**REQUEST FOR TENDER
ORANGUTAN OUTDOOR EXHIBIT CONSTRUCTION
RFT#: TZC T 10-2020-02
ADDENDUM # 2**

Date Issued: 2020 March 13
Project Name: **Toronto Zoo Orangutan Outdoor Exhibits**
To: Ben Knoop
Toronto Zoo
361A Old Finch Avenue
Toronto, ON M1B 5K7
Project Number: 18-1-086
RFT Reference No.: TZC-T-10-2020-02 (issued 2020-02-18)

ADD #A002

3 SECTION
AR-141 SCALE - 1:50

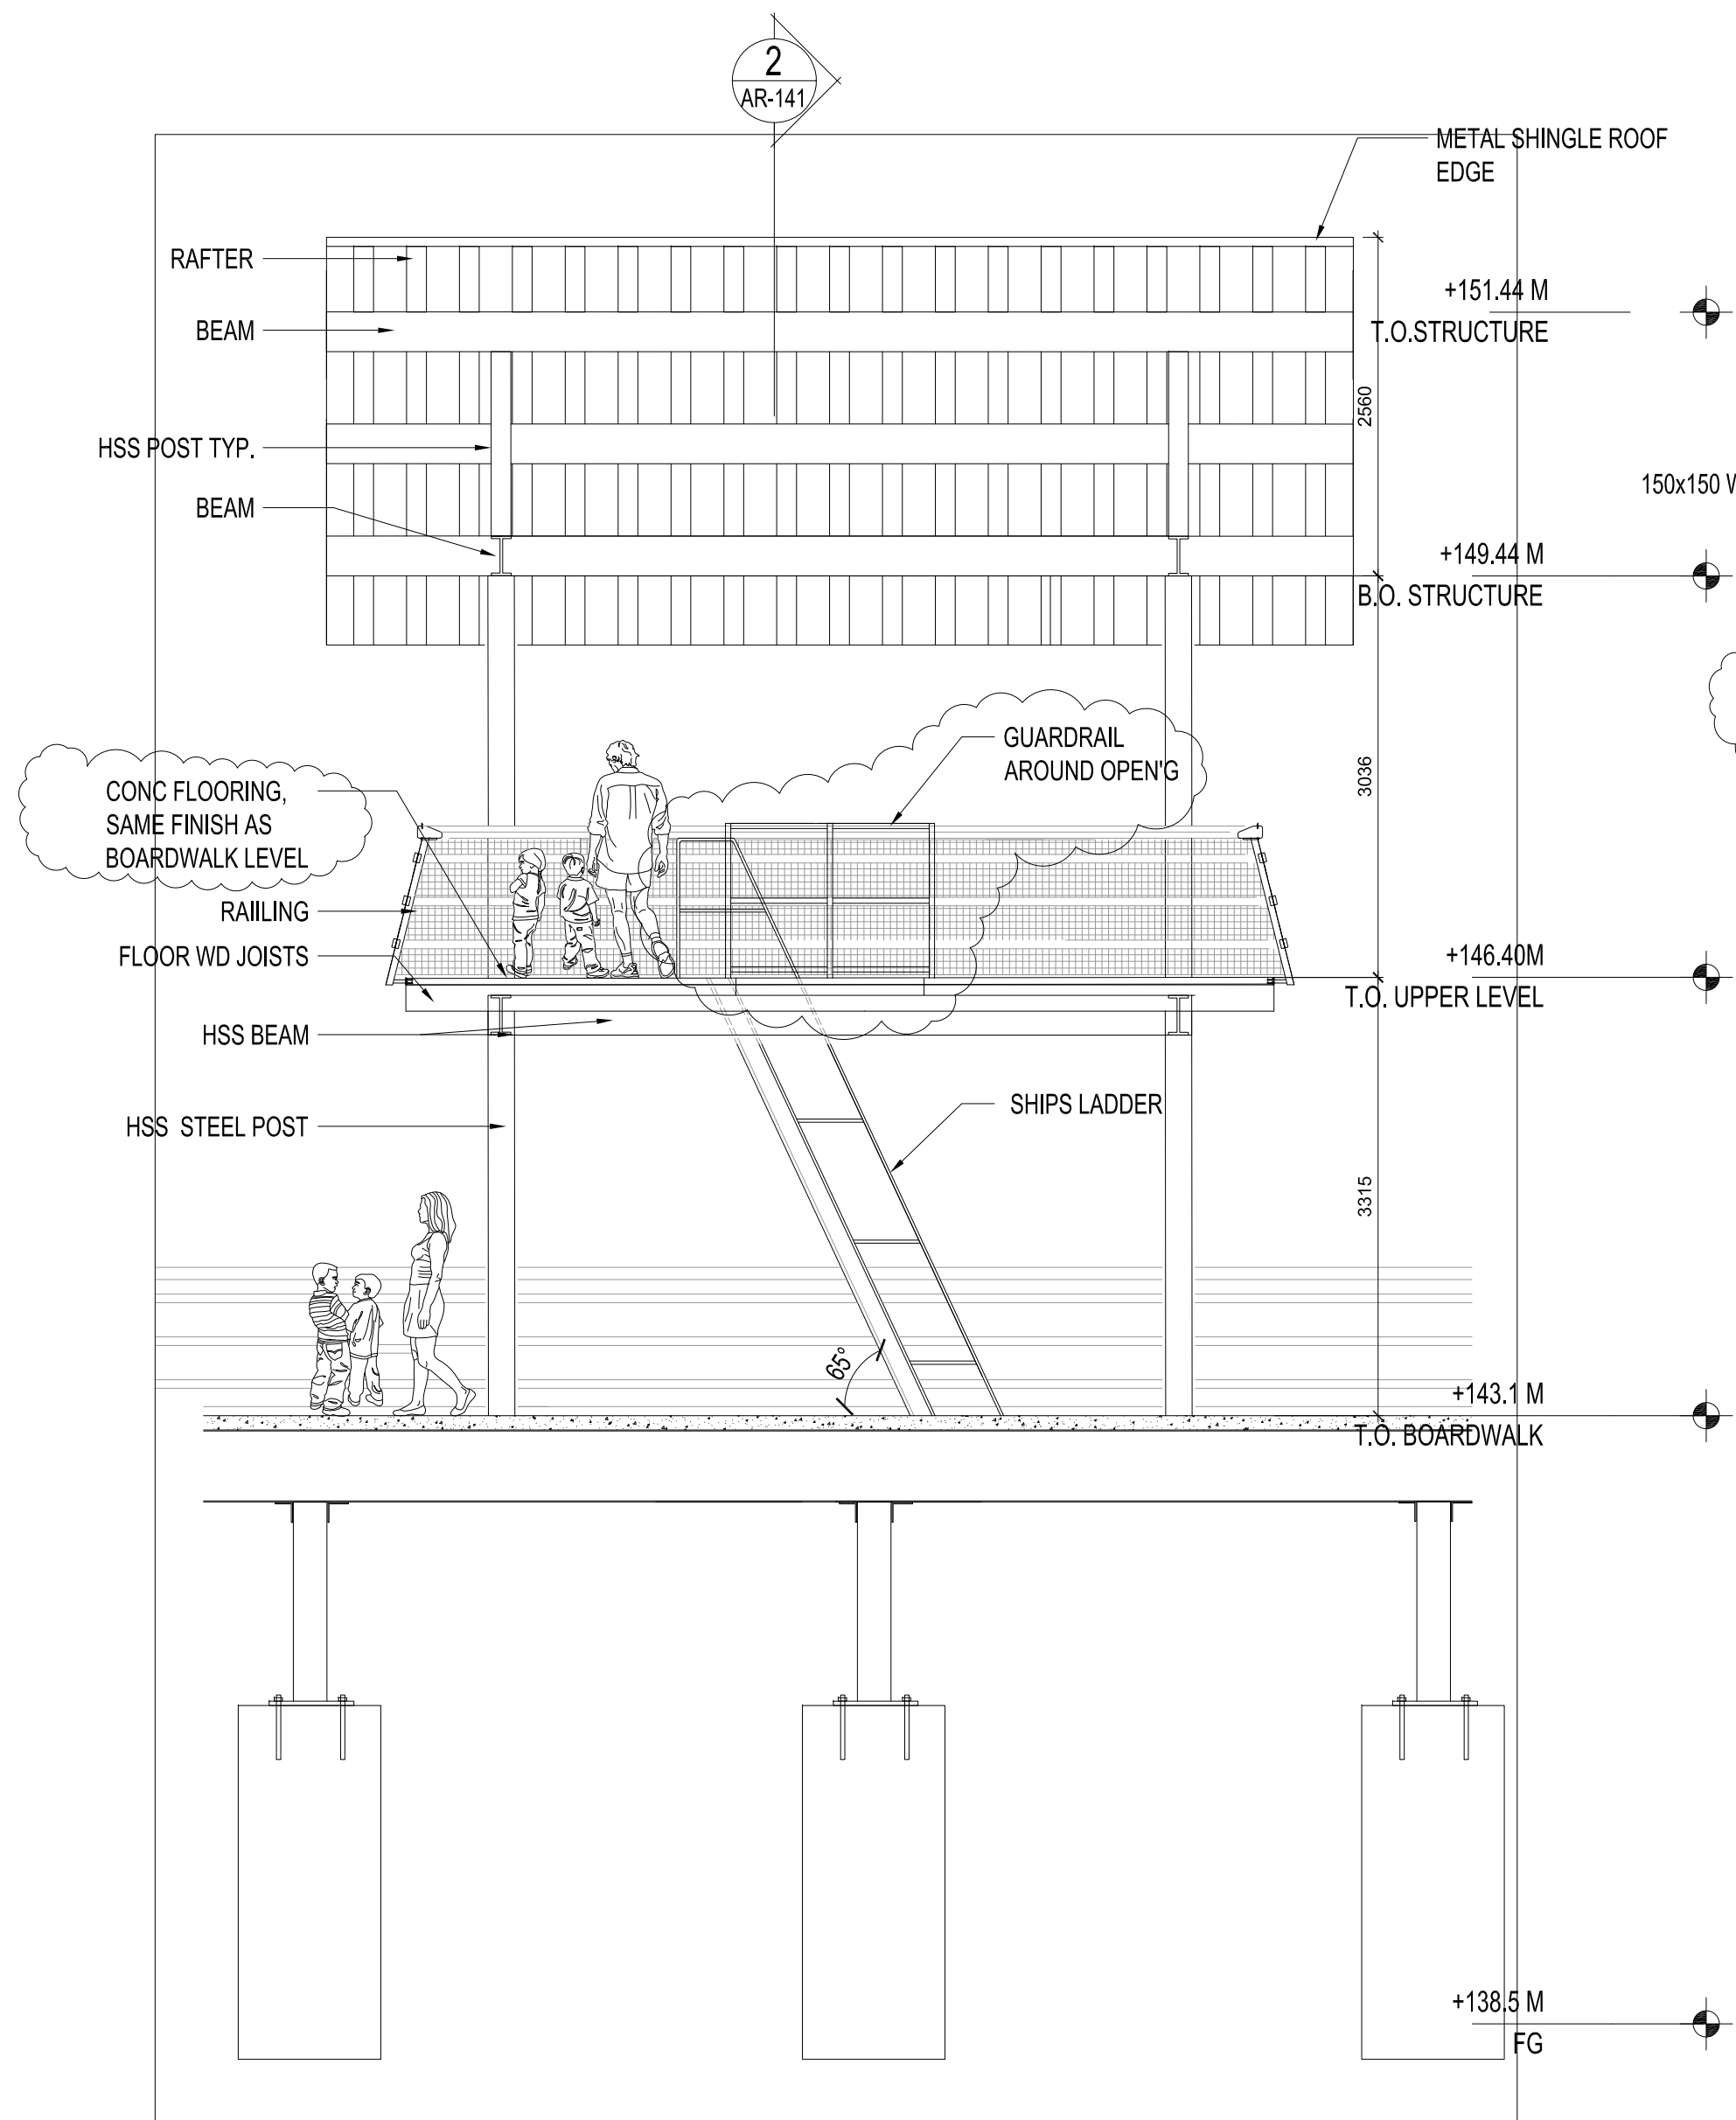
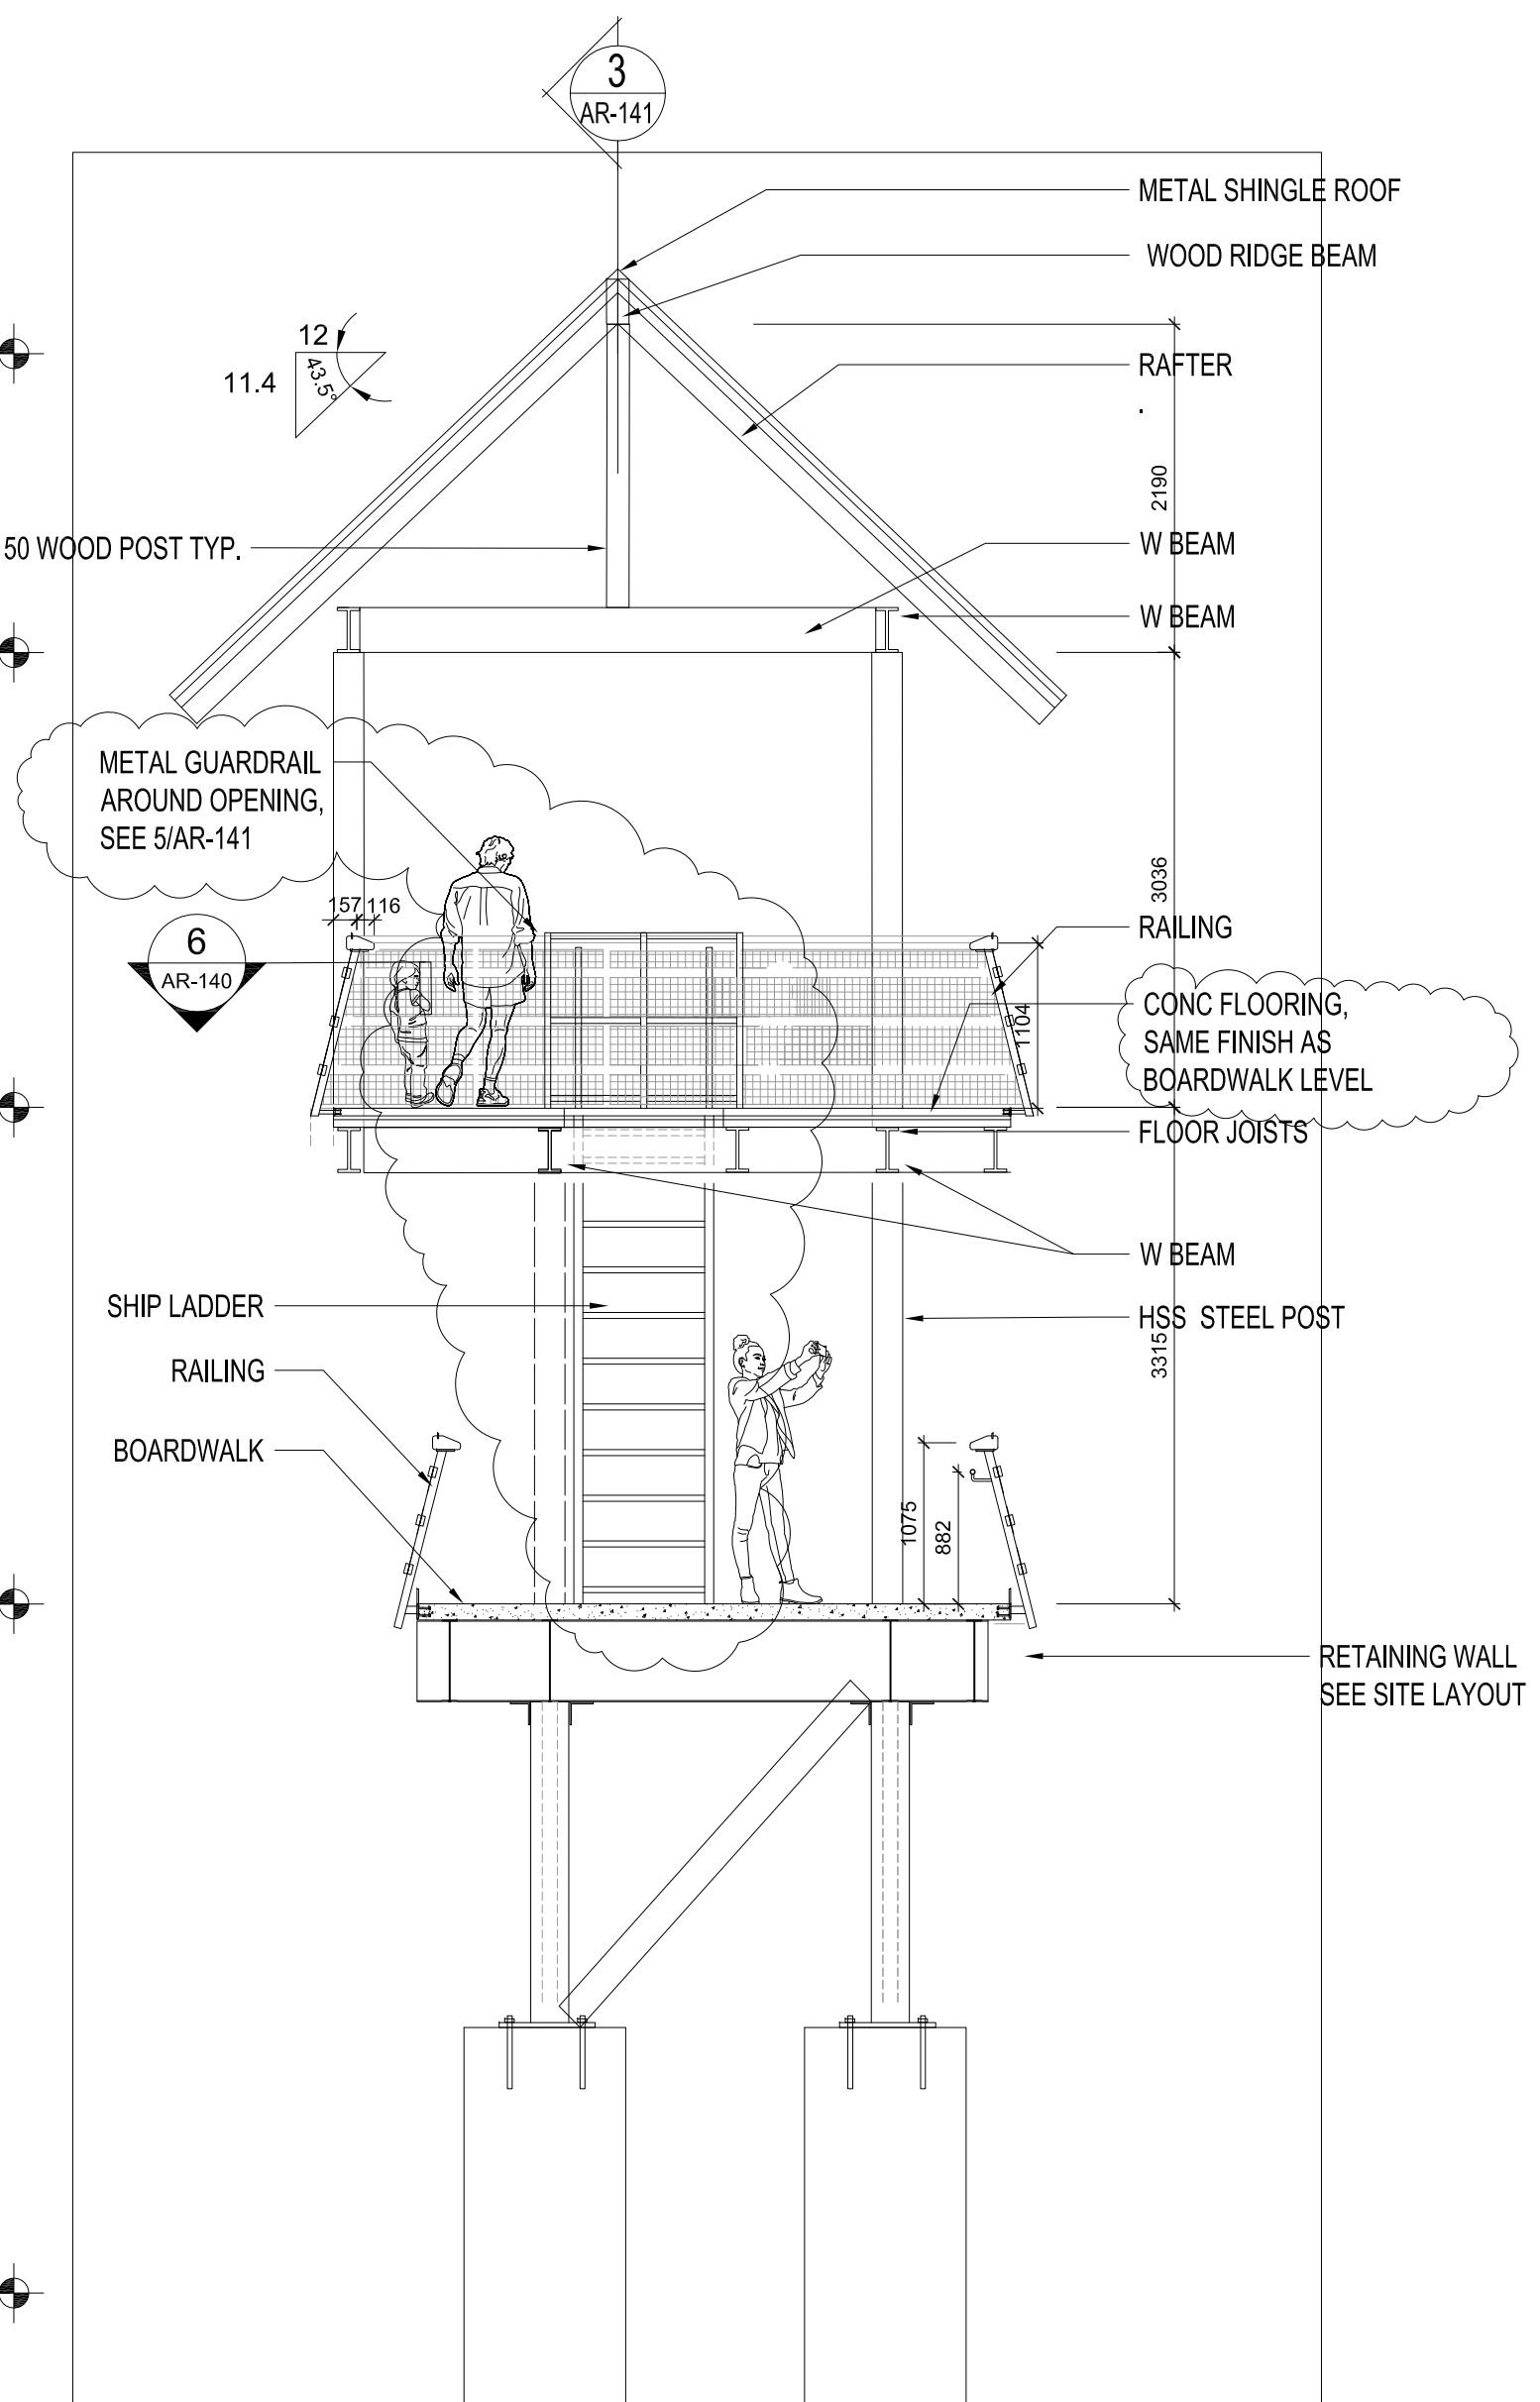
(A)		7 Drawing 3/AR-140 & 2, 3, 4/AR-141 – The upper floor deck is concrete on metal deck as per structural plan 3/S-210 & section 2, 3/S-810. Not cedar floor. Please clarify.	Zediler/RJC	Arch details to be revised to match structural's dwg (conc on metal deck).

12 FULL MOAT WALL
AR-180 SCALE - 1:50

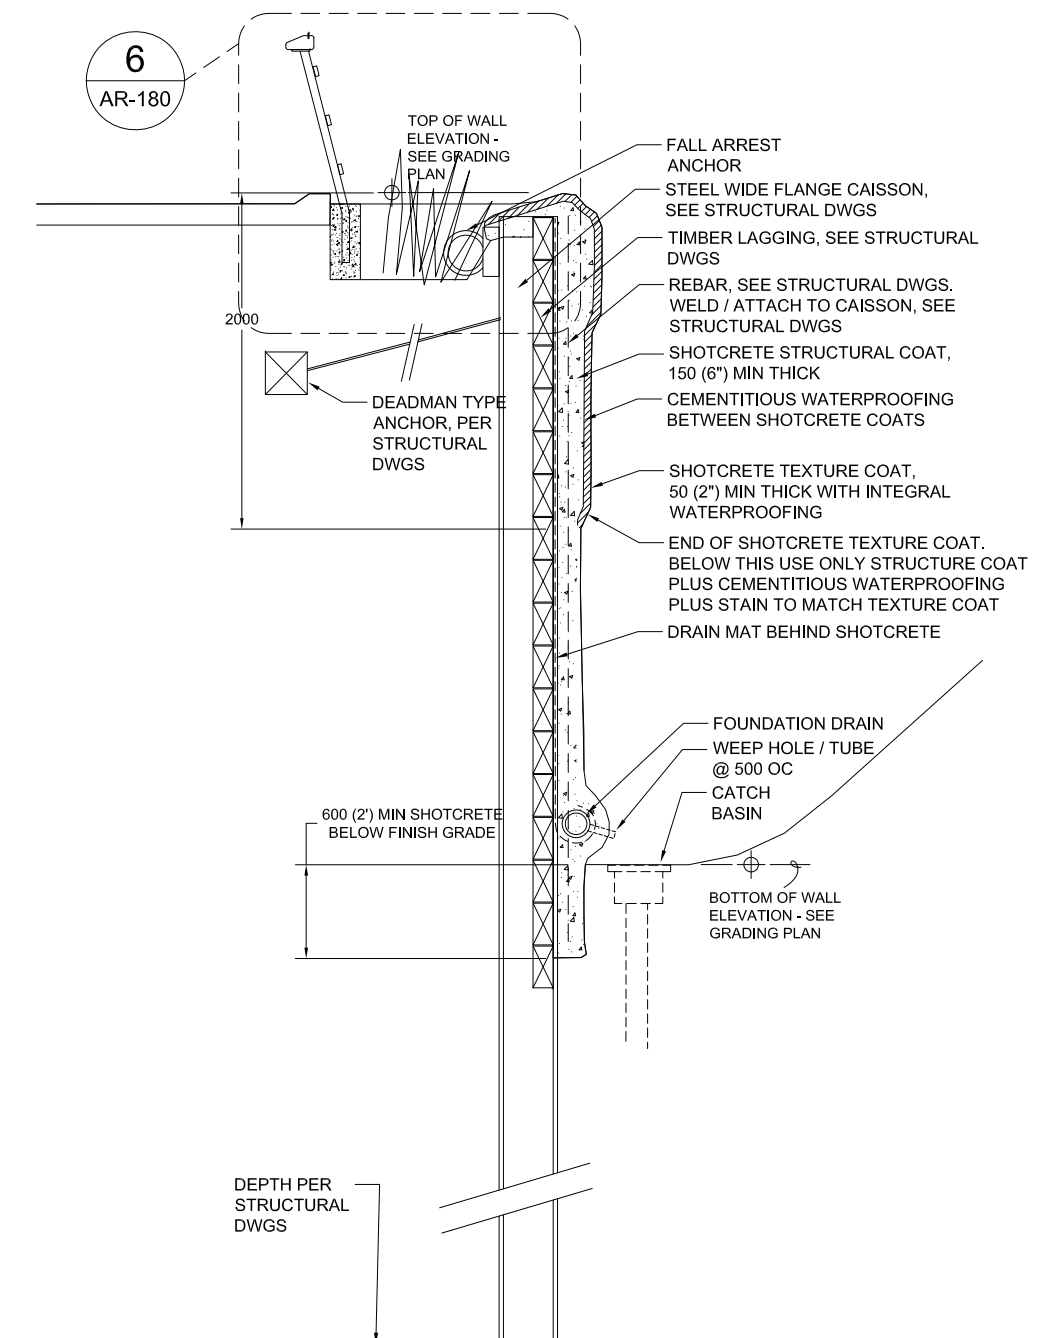
(A)		4 Cementitious Waterproofing Section 071600 – Where does it apply to?	Zeidler	Use in moat wall – see 12/AR-180.	
		5 Finish Hardware Section 087000 & Door Schedule in drawing AR-002:
